STATE OF WASHINGTON
DEPARTMENT OF ECOLOGY

Re: Opinion pursuant to WAC 173-340-515(5) on Proposed Remedial Action for the following Hazardous Waste Site:

- Name: Former Sears Automotive Center (The Home Depot)
- Address: 2753 Utah S. Seattle, WA
- Facility/Site No.: 90796658
- VCP No.: NW1755

"Site Plan"

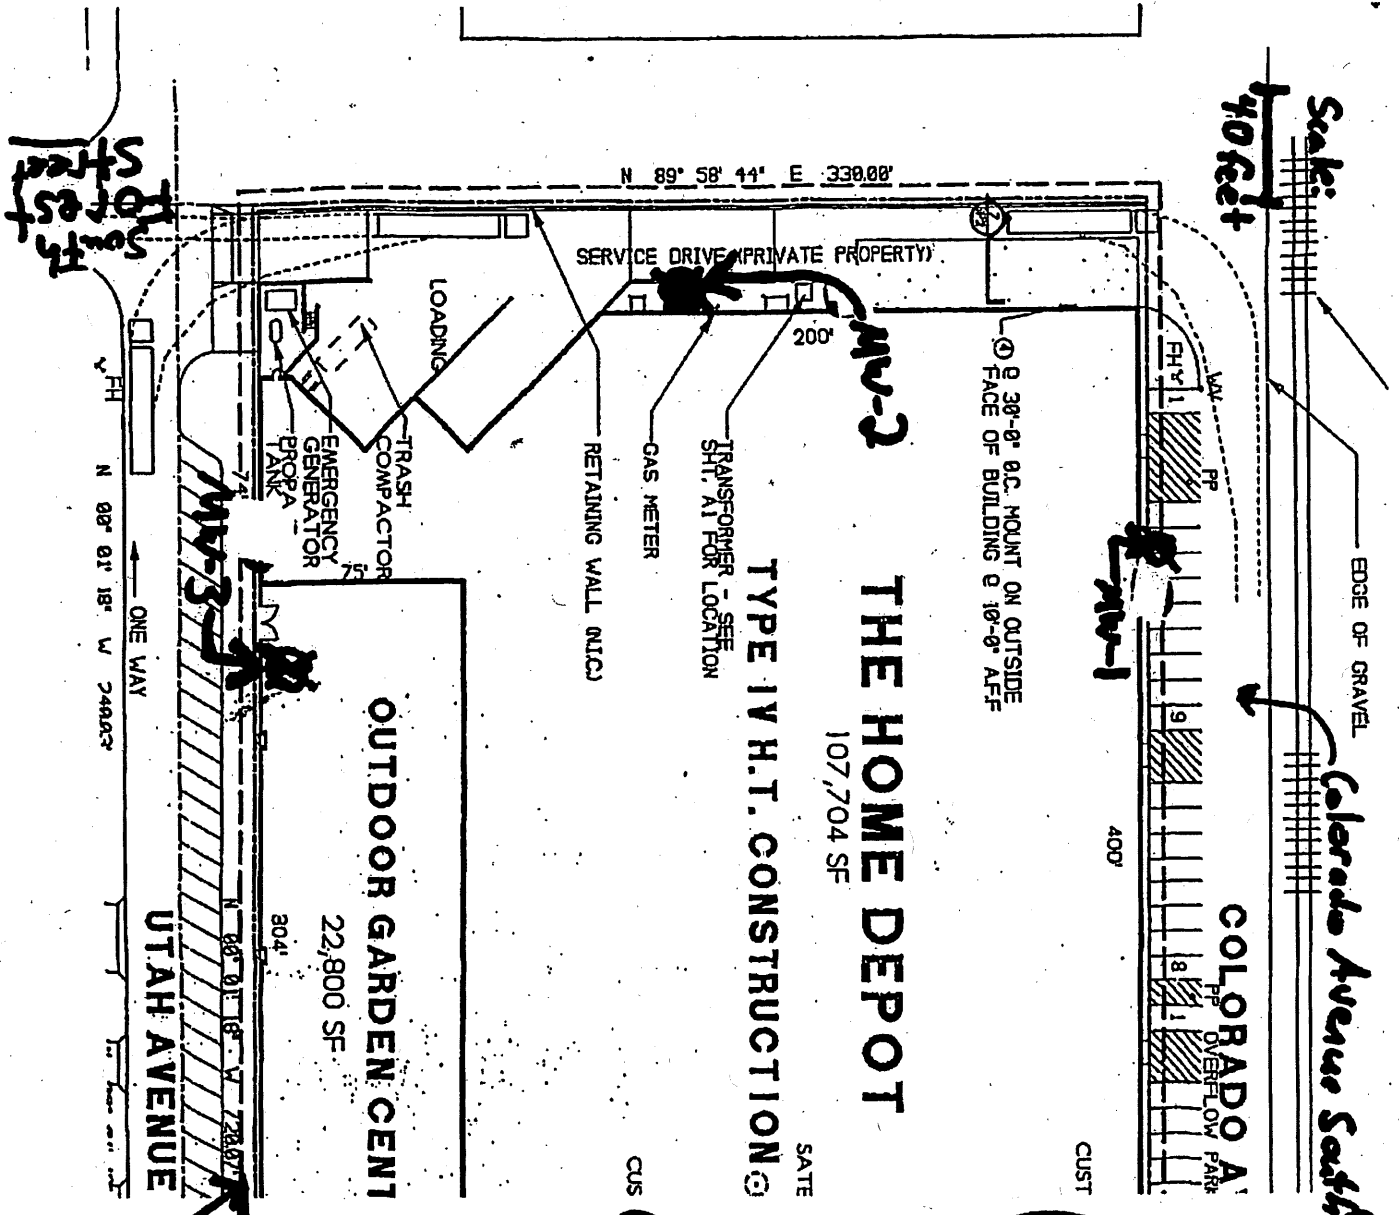
If groundwater is found to be contaminated additional groundwater investigation may be required. Also, if groundwater is found to be impacted at the proposed location of MW-1, additional wells will be required to determine if contaminated groundwater is migrating to Elliott Bay.

The lateral extent of petroleum contaminated soils (PCS) was not properly addressed during the Underground Storage Tank removal or in the subsequent reports listed above. Therefore, at the minimum, proper soil sampling must be performed during the construction of the three proposed groundwater monitoring wells as described in the report *Groundwater Monitoring Well Installation Proposal*, dated 03/13/2007 Environmental Associates, Inc. If contamination is found at these locations, additional sampling may be required.
